PEER REVIEW OF THE TRAFFIC IMPACT STUDY

Re: TJKM Peer Review of Lafayette Residential Development Transportation Impact Study Dated September 23, 2014

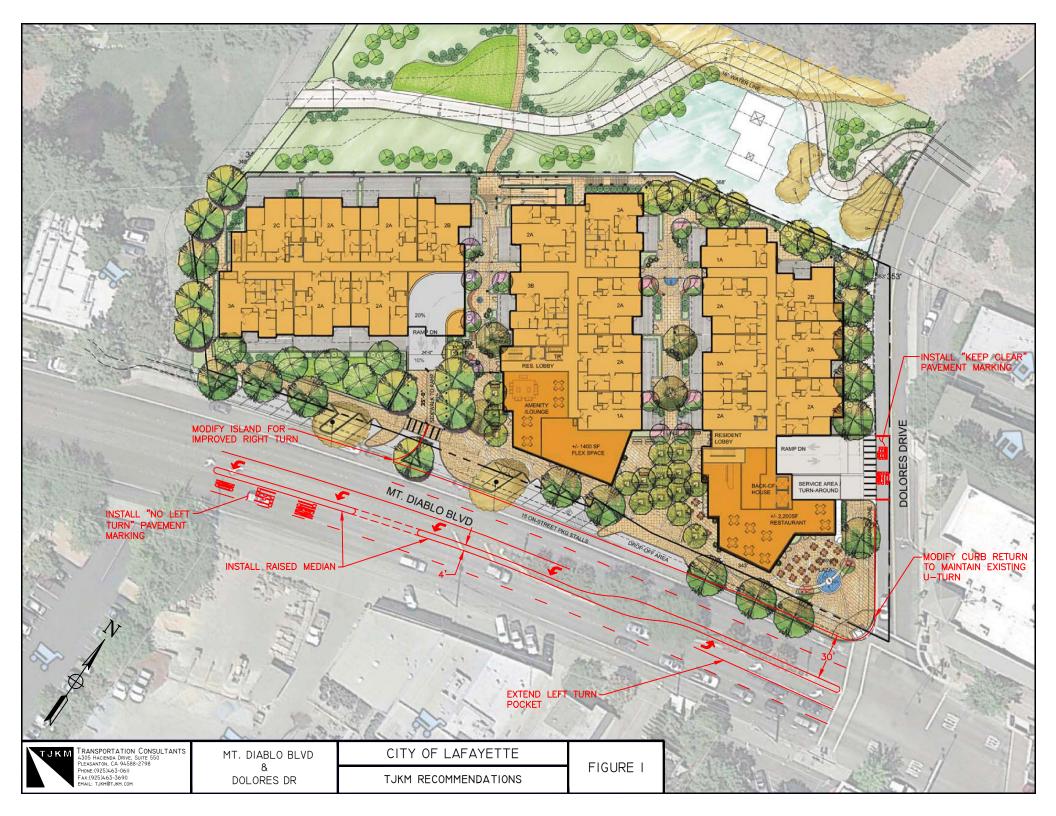
Truck Loading Dock The project proposes to utilize Dolores for maneuvering into and out of the truck dock. More information should be provided. TJKM suggests that Auto Turn or a similar program be utilized to demonstrate how truck maneuvering would take place. Also, the traffic study should indicate the approximate number of trucks per day or week that would be using the dock and the size of the trucks that would be utilized. There is the potential for a truck to

overhang the sidewalk and interfere with visibility and sight distance of and from autos using the garage entrance. The photo illustrates the "tightness" of Dolores in this area.
